Listed Building Consent – Uxbridge (Redesign for CRMS route on platform 1)

| Project Programme | PLU OPO CCTV – Listed Building Consents | | |
| Stage | Detailed Design | | |

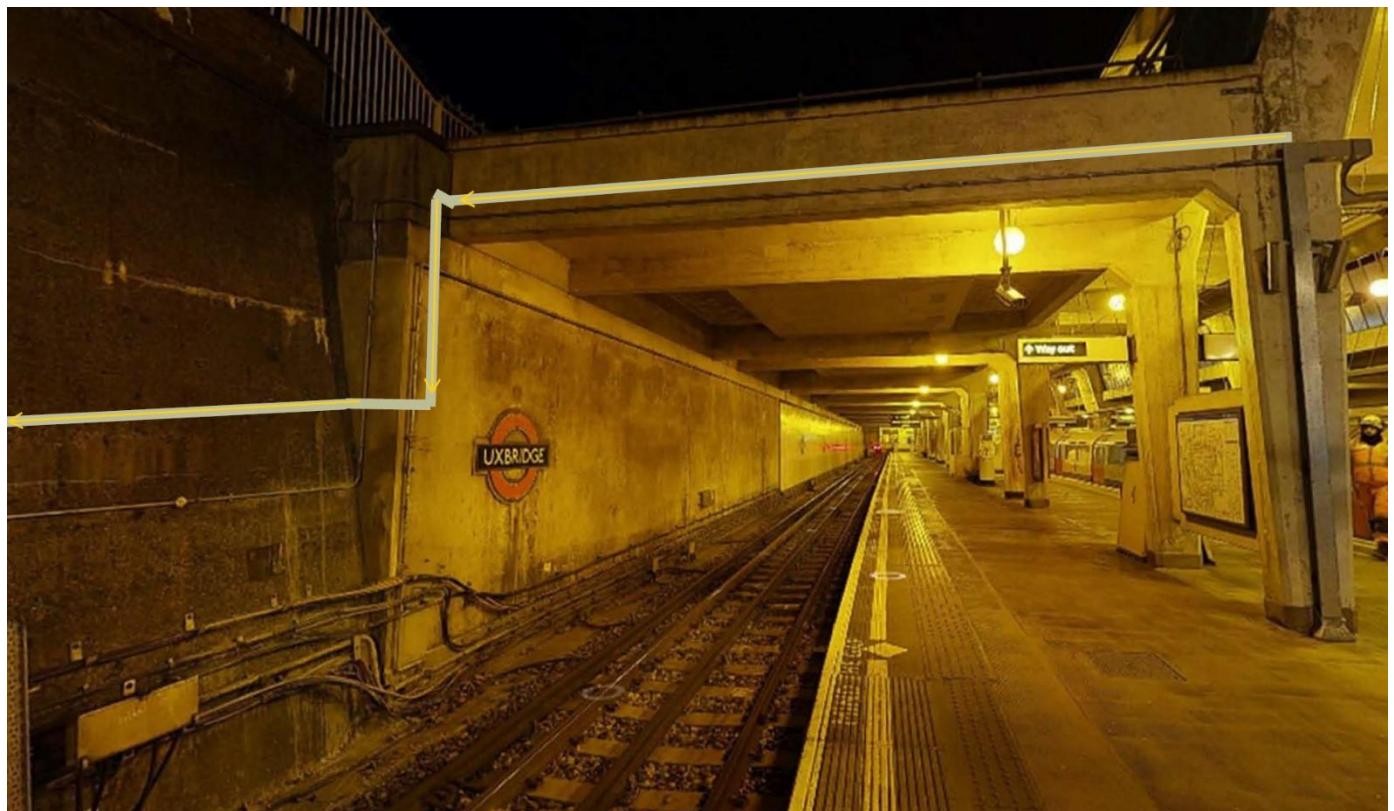
- Underside of the trainshed will not support new CRMS due to constraints of the protective netting – where its purpose is to mitigate the chance of loose debris from the structure falling on to the track/platform. Our construction team have held discussions with the civils maintainer of the netting (as well as station staff) in which we have been told we cannot remove the netting for a substantial period of time due to health & safety concerns of possible falling debris during traffic (public) hours.

- Option 1 – CRMS to run along the underside of netting but on the non-platform side – [whilst this may be feasible, this would result in a significant increase in the amount of visible CRMS from public standing areas \(approximately 60m+\)](#).
- Option 2 – CRMS to run along the roof of the trainshed - [the roof is not accessible due to a non-compliant ladder. Even if we further explored the option to find temporary means in order to gain access for install, we'd still face issues with the general maintenance of the new assets. Additionally, the new CRMS will have to loop down from the trainshed roof eventually so there will always be a small section of visible CRMS.](#)

CRMS Hidden from public view = Dashed Lines

CRMS Visible= Solid Lines

All CRMS will be colour-coated to match the finish of the substrate to which it will be affixed in alignment with the [LU Design Idiom](#).
